UNITED STATES PATENT AND TRADEMARK OFFICE

| APPLICATION NO. | FILING DATE | FIRST NAMED INVENTOR | ATTORNEY DOCKET NO. | CONFIRMATION NO. |
|---|-------------|----------------------|---------------------|------------------|
| 10/681,473 | 10/08/2003 | Missoum Moumene | DEP 5169 | 7470 |

DATE MAILED: 11/30/2005

DETAILED ACTION

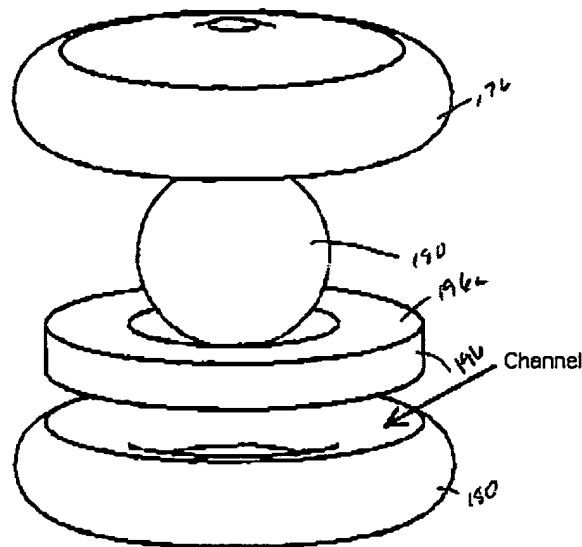
Furthermore, the motion disc includes a peripheral elastomeric shock-absorbing component, 196, comprising a first surface, 196a, contacting and attached to the first peripheral surface of the first endplate, and a second surface, 196b, contacting and attached to the second peripheral surface of the second endplate. Moreover, each peripheral surface of the shock-absorbing component is capable of being tenaciously attached to the respective inner surface of each plate (see Figures 11E-11F and paragraph 0062, particularly lines 4-7).

The inner surface of each opposed endplate comprises a channel, wherein each peripheral surface of the shock-absorbing component is adapted to fit within the respective channel (see Figure 11F below). Songer et al. teaches the use of a sheath adapted to enclose the articulation surfaces and a lubricant disposed on the first articulation surface (see paragraph 0012, lines 5-10).

Examiner respectfully disagrees with applicant's argument that *Songer et al.* does not teach or suggest that the inner surface of each prosthetic endplate comprises a channel, since the inner surface of each prosthetic endplate does comprise a channel, wherein each peripheral surface of the shock-absorbing component is adapted to fit within the respective channel (see Figure 11F above). Furthermore, it has been held that the recitation that an element is "adapted to" perform a function is not a positive limitation but only requires the ability to so perform. It does not constitute a limitation in any patentable sense. *In re Hutchison*, 69 USPQ 138.
